FTI-FDK2: Vehicle Coverage and Preparation Notes

Make	Model	Year	Install	CAN	Lights	Trunk/Hatch	POC	I/O Changes
DL-FM6 Lincoln	MKZ Hybrid PTS	2013	Type 1/2	OBD-II	Park / Auto A	gry/yel (6)	N/A	Green White/Blue N/A

Overview: The initial production release of the FTI-FDK2 harness did not account for the use of aftermarket RF components and does not supply the connection that programs the module for aftermarket RF use. This issue affect the initial release and is currently being addressed in production, but for installations using aftermarket RF a field repair is provided below.

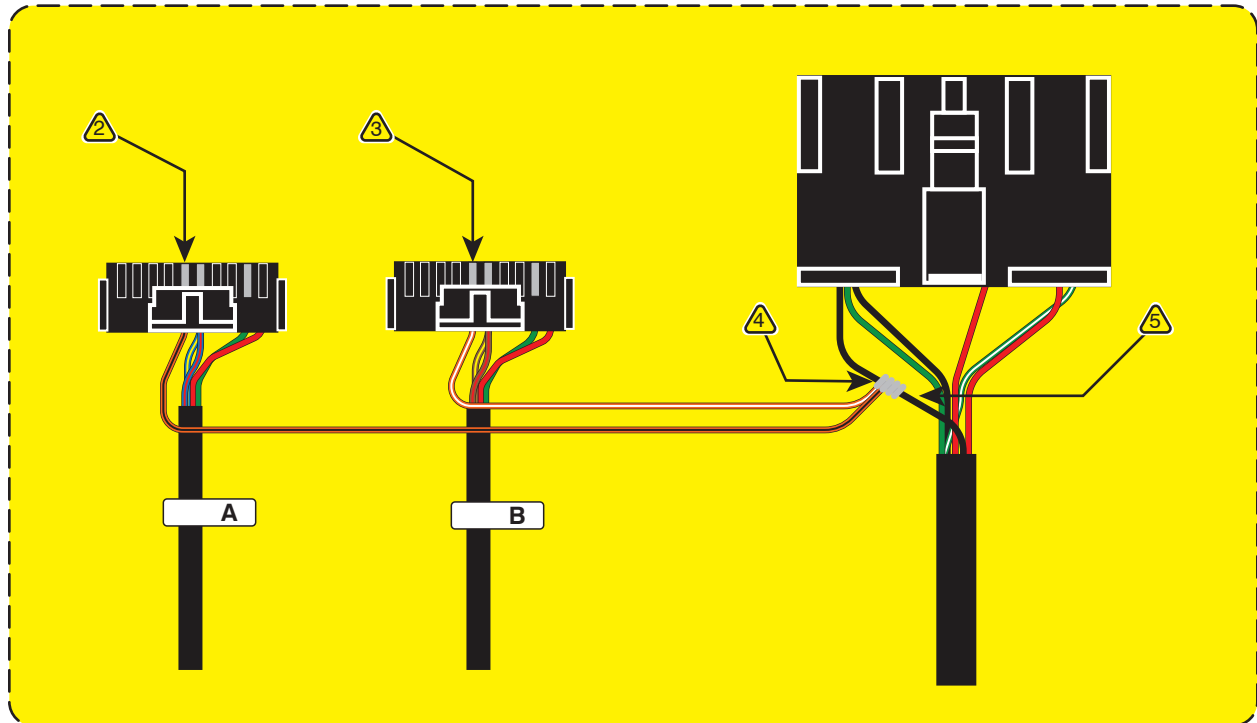
Issue: The orange black wire is not included in the BLADE connector. This wire must be present throughout steps 1 & 2 of the module programming procedure in order for the module to properly control the vehicle's door locks via aftermarket RF. The required wires can be sourced from the harness originally supplied with the BLADE cartridge, inserted into position #5 of each BLADE connector, and attached to either of the black ground wires in the CN1 connector of the harness.

- 1.) Use a pick tool to depress the locking tab on the terminal connector of the orange/black & orange/white wires in pin positions #5 & #15 of the BLADE connector that was supplied with the BLADE module, remove wires for relocation.
- 2.) With locking tab repositioned, insert orange/black wire into position #15 of the connector marked [A].
- 3.) With locking tab repositioned, insert orange/white wire into position #15 of the connector marked [B].
- 4.) Extend the orange/black & orange/white wires to the CN1 connector, strip ends and attach to one of the black ground wires.
- 5.) Once the wires have been securely connected and insulated, you may proceed with module programming.
